Re: **RESPONSE TO INFORMATION REQUEST**
56 Woodroffe Avenue, Main Beach (Lot 5 on M73840)
PN81/01/DA2

We act on behalf of Mr. Jusuf Chandra with respect to the proposed Attached Dwelling at 56 Woodroffe Avenue, Main Beach.

Pursuant of Section 3.3.8 of the *Integrated Planning Act 1997*, we submit the following response to the Information Request issued by the Gold Coast City Council on the 4th of December 2007.

GROUND FLOOR PLAN

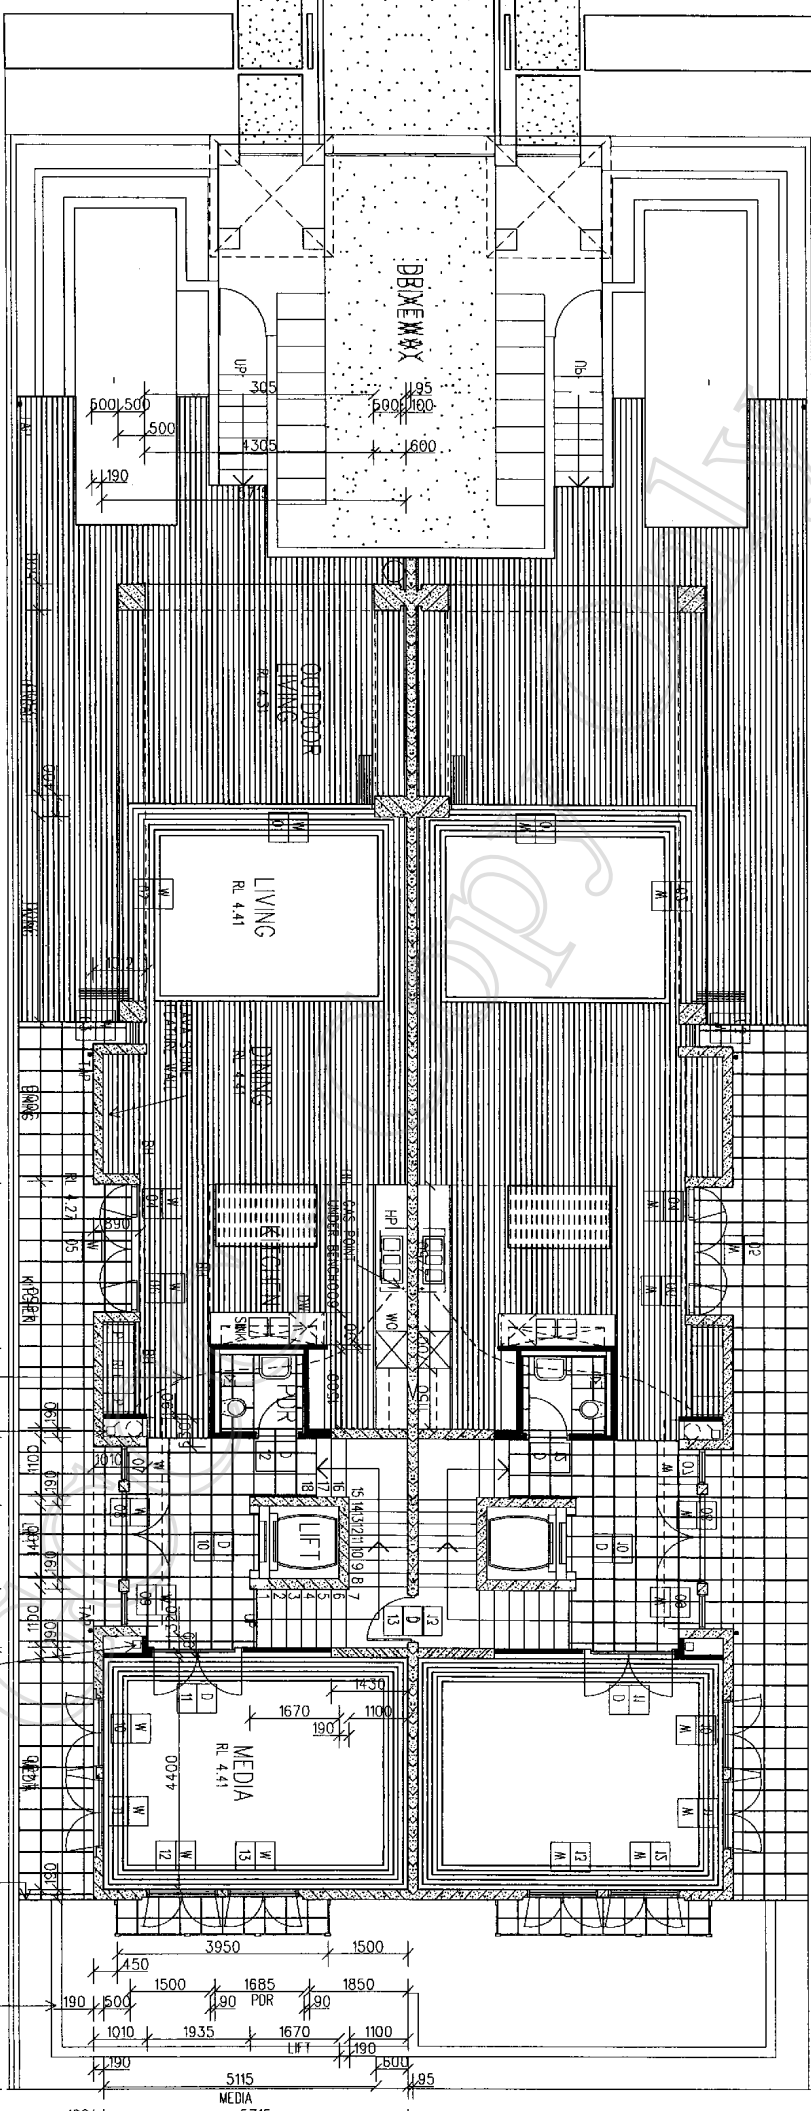
1. Site Coverage

Please find attached plan of development with area calculations for site coverage purposes (Drawing WD-102) prepared by Ian Hosking Architect.

The total site coverage for the development as constructed is 50.7%.

This building was constructed in accordance with an approval issued under the 1994 Town Plan. Section 4.11.2.2 of the superseded Town Plan allowed Duplex Dwellings to be developed to a maximum of 50% site coverage (subject to the provision of adequate open space around the building). The Council's Decision Notice dated April 1st 2003 approved maximum site coverage of 44%. The building appears to have been constructed with a site coverage in excess of this approval.

While it is not possible without full documentation to understand how these circumstances came about we have a view that the ground floor plans only (i.e. excluding the terraces on the first and second floor) have a site coverage of approximately 44% and this error could have given rise to the misrepresentation which appear to have occurred.

Notwithstanding these circumstances, Council does have power under PC3 of the Residential Choice Domain to accept an alternate solution to AS3.1.2 (40% site coverage for residential uses other than dwellings). This is based upon the PC which states that 'the site coverage of all buildings must not result in a built form that is bulky and visually intrusive'.

SECTION 1

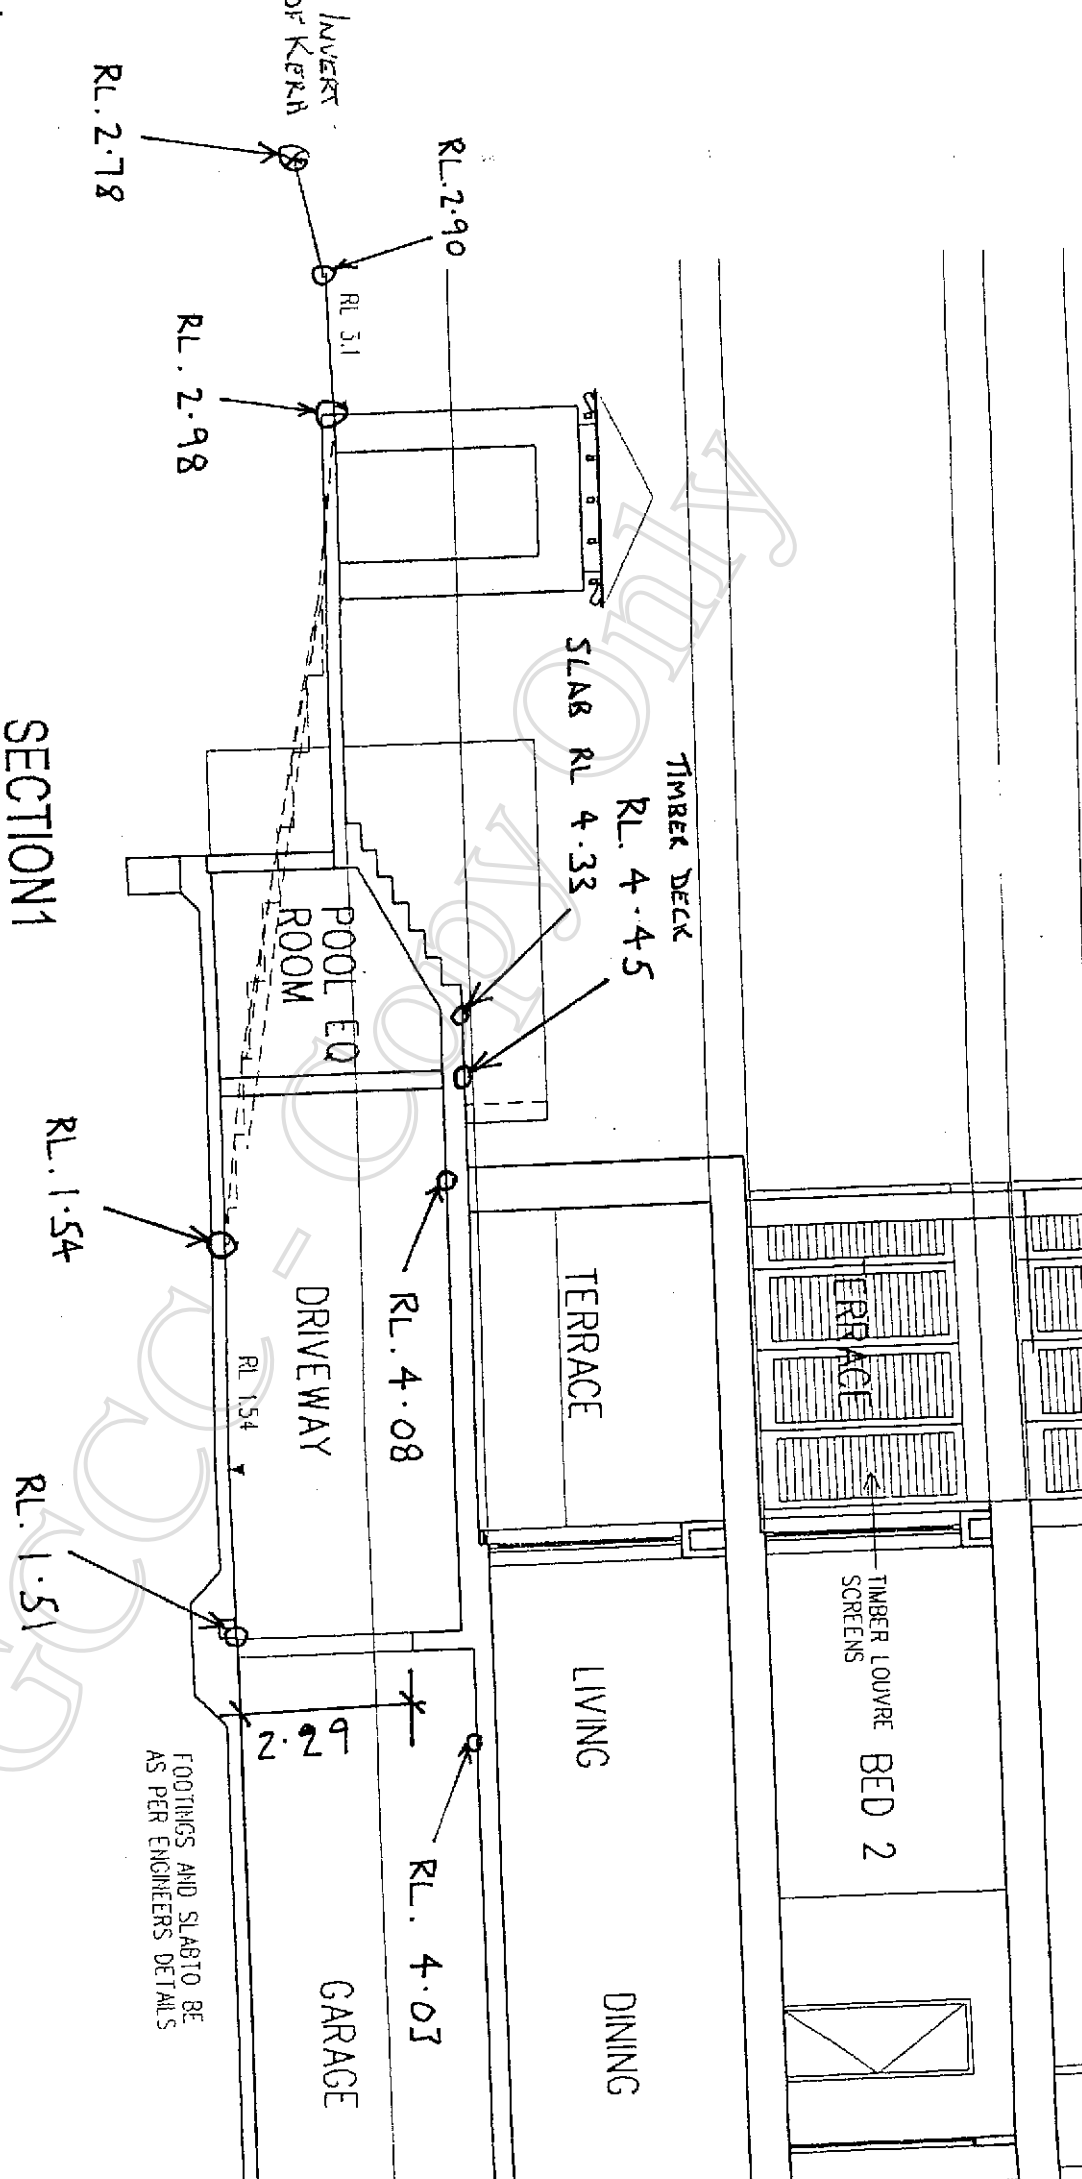
2. Basement Levels

Please refer to the attached Survey Plans prepared by Hanger and Kelly Pty Ltd. Because the building has been constructed the basement and ground levels can be surveyed. The finished ground level at the basement is at RL3.00. The top of slab of the basement is at RL4.33. The basement therefore exceeds 1m above finished ground level, constituting an addition storey as per the 'Storey' definition under the Town Plan.

1. We hereby certify that the as constructed grades of the ramp accessing the basement of this development are as shown on the Sketch provided (6147:R).
2. The sketch showing the elevation of the development shows all levels as measured onsite. These levels reflect an approximate height from the top of the slab above the basement to natural surface being 1.20m - 1.30m.
3. The minimum vertical distance at the entrance to the basement is 2.29m.

The Finished Floor Level of the Basement has a value of RL. 1.510 (AHD).

Longsection of Ramp
 Scale 1:100

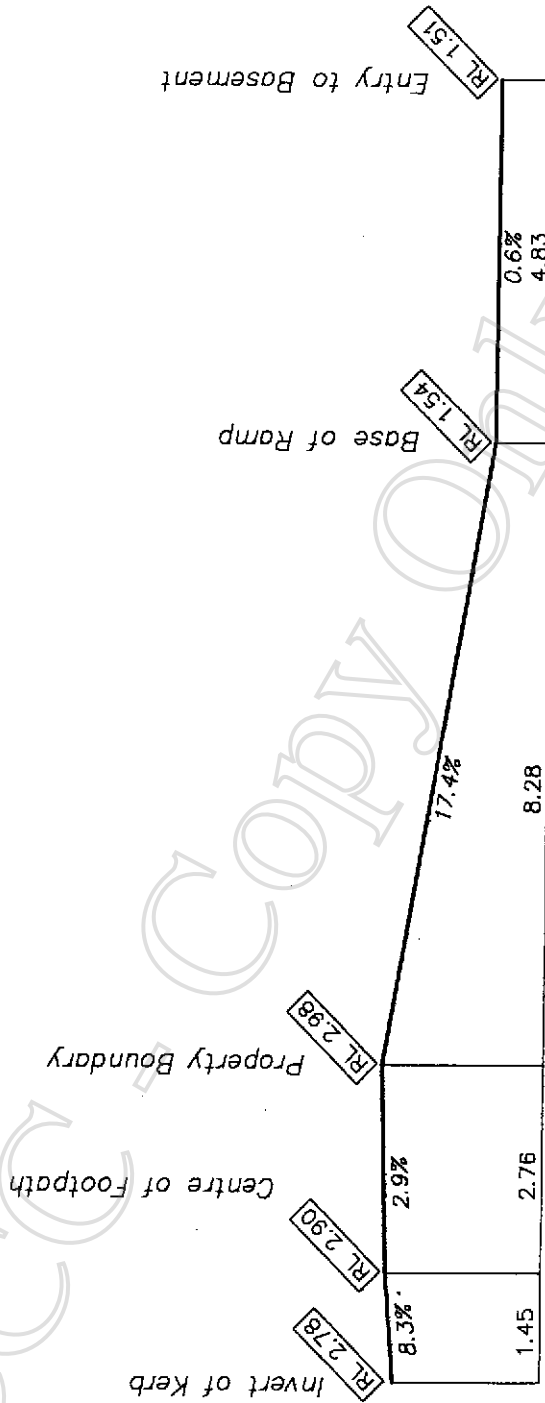
3. Driveway Long Section

Please refer to the attached driveway section prepared by Hanger and Kelly Pty Ltd. The grade change of the driveway does not exceed 18%.
